**Iowa Department of Transportation**  
 Highway Division  
 STANDARD DESIGN - 44' ROADWAY, THREE SPAN BRIDGE  
**PRETENSIONED PRESTRESSED CONCRETE BEAM BRIDGES**  
 MARCH, 2007

**PIER BEARING DETAILS H44-37-07**

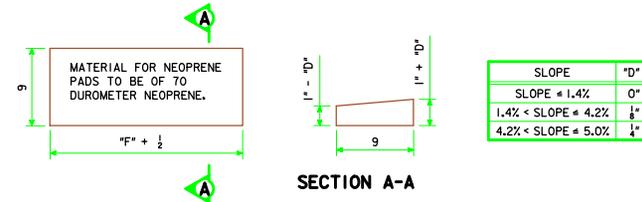
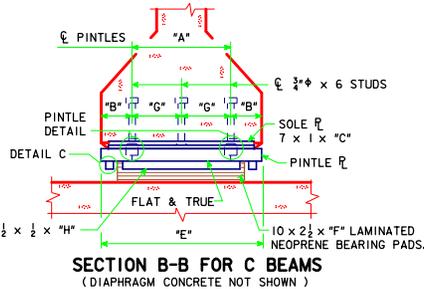
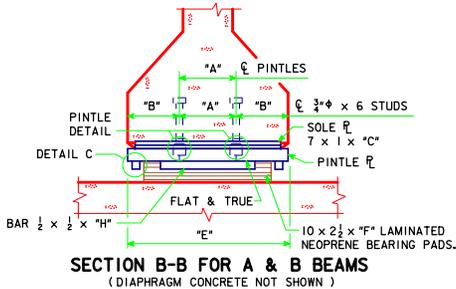
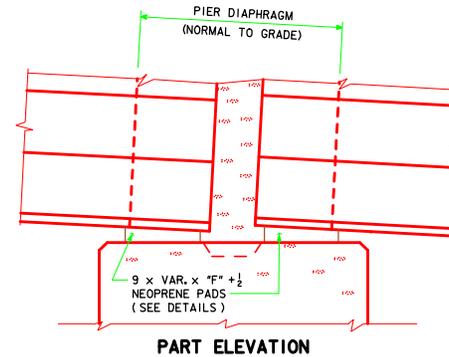
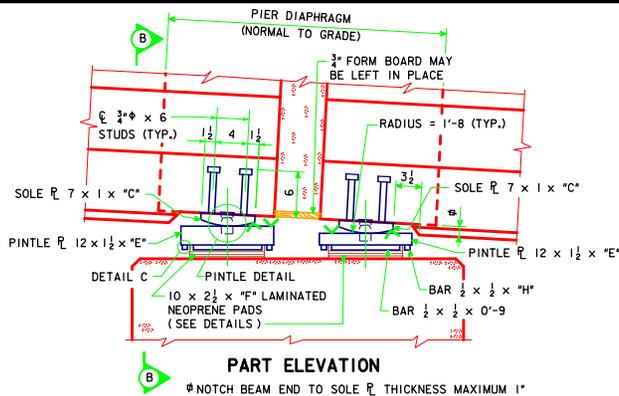
CORRECTION 06-11 - THE REFERENCE TO BAR DIMENSION "A" WAS CHANGED TO "H" IN SECTION B-B FOR A & B BEAMS.
